## FURZEHALL FARM, WICKHAM ROAD SIDMOUTH STREET, FAREHAM, HAMPSHIRE, PO16 7JH NOTES: CREST NICHOLSON T: 01329 283 225 F: 01329 237 004 AA, & BB - PROPOSED E: EMAIL@HGP-ARCHITECTS.CO.UK W: WWW.HGP-ARCHITECTS.CO.UK **ELEVATION** 26/07/2012 DATUM LEVELS OMITTED AND PARAPET DIMENSIONS ADDED 24/07/2012 REFUSE STORE TO SOUTHERN BOUNDARY AMENDED & DIMENSIONS ADDED 16/07/2012 LEGEND OF AMENDMENTS REVISED AND MINOR CLIENT AMENDMENTS TO ELEVATIONS Date Description By PM HGP Architects Ltd. Scale @ A0: 1:100, Drawn by: SR Copyright Reserved. 12.036.160 Date: © 31.05.12 Checked by: MLE **PLANNING**

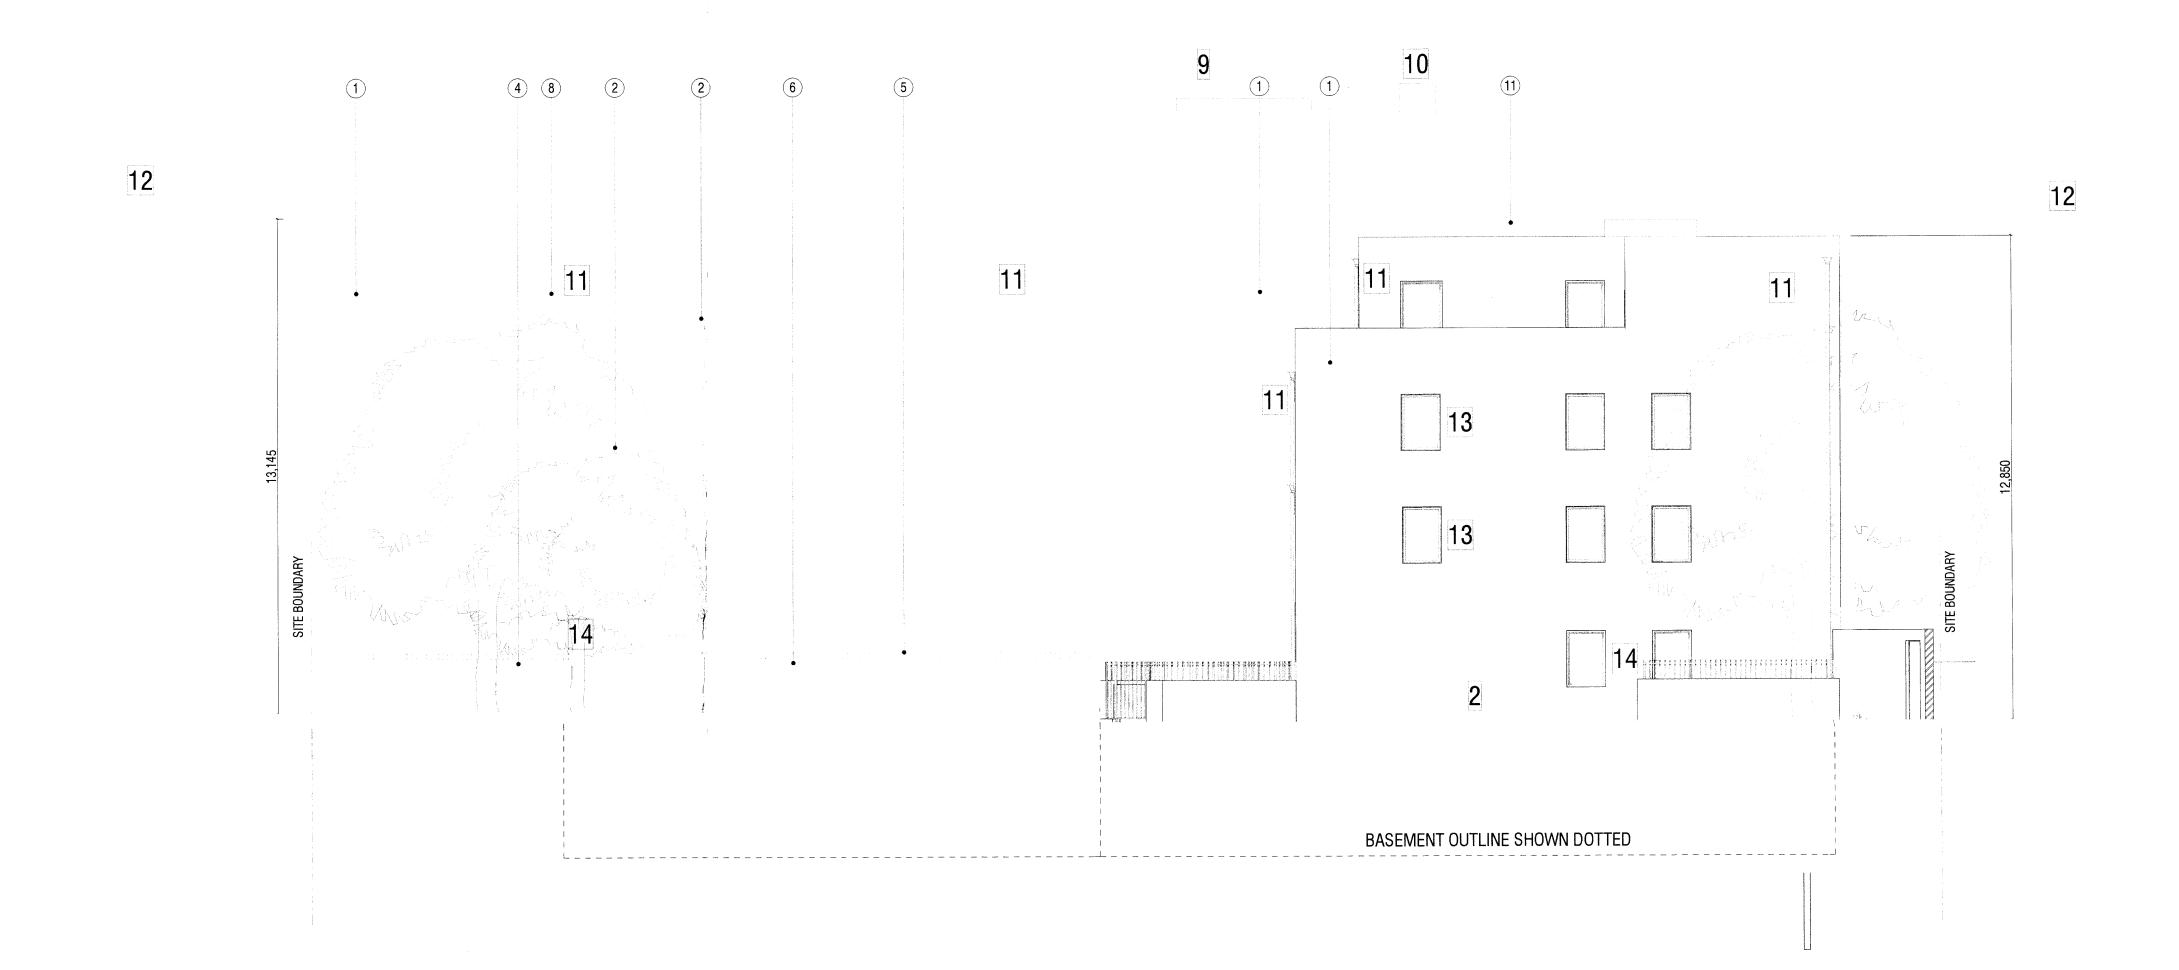
2No. COLUMNS TO SUPPORT UPPER FLOORS
LIGHTWELL REDUCED TO LESSEN IMPACT ON THE LISTED BOUNDARY WALL
2No. DOUBLE DOORS AMENDED TO FOLDING GLAZED WALL TO IMPROVE
DAYLIGHT TO HABITABLE ROOM OF PLOTS 33-38
LIGHTWELLS TO PLOTS 5-7 REDUCED TO ALLOW MAINTENANCE ACCESS TO THE
COMMUNAL GARDENS

BIN STORAGE ARRANGEMENT AMENDED TO IMPROVE THE ENTRANCE INTO THE

PRIVATE LOBBY ARRANGEMENTS OFF THE MEWS ACCESS AMENDED TO PLOTS

33-38 AMENDED, REFER TO ELEVATION A-A, & BINS RELOCATED TO THE

12 - PARAPET HEIGHTS INCREASED TO ACCOMODATE THE BIO DIVERSE ROOF

15 - WINDOW OMITTED TO WEST ELEVATION OF NORTH BLOCK AT 4th FLOOR
16 - ARRANGEMENT OF THE OPAQUE WINDOW PANELS REVISED TO SUIT INTERNAL

13 - ADDITIONAL OPAQUE WINDOWS ADDED TO SOUTH ELEVATION

17 - WINDOW AND DOORS AMENDED TO SUIT INTERNAL LAYOUTS
18 - WIDTH OF RECESSED BALCONY TO NORTH ELEVATION REDUCED

22 - BUILDING HEIGHTS AMENDED TO ACCOMODATE SITE LEVELS

ROOF VENT OVER THE COMMUNAL STAIR OF THE SOUTHERN BLOCK ADDED

5 - REDUCTION OF INTERNAL LOBBY TO ACCOMMODATE EXTERNAL REFUSE STORE & IMPROVE ASPECT OF PLOT 5.

9 - SMOKE SHAFT ADDED TO NORTHERN BLOCK 10 - CHP FLUE CHIMNEY ADDED TO NORTHERN BLOCK

11 - RAINWATER PIPES ADDED TO ELEVATIONS

21 - SOUTHERN BOUNDARY TREATMENT CLARIFIED

14 - RAILING HEIGHT LOWERED TO 1500MM
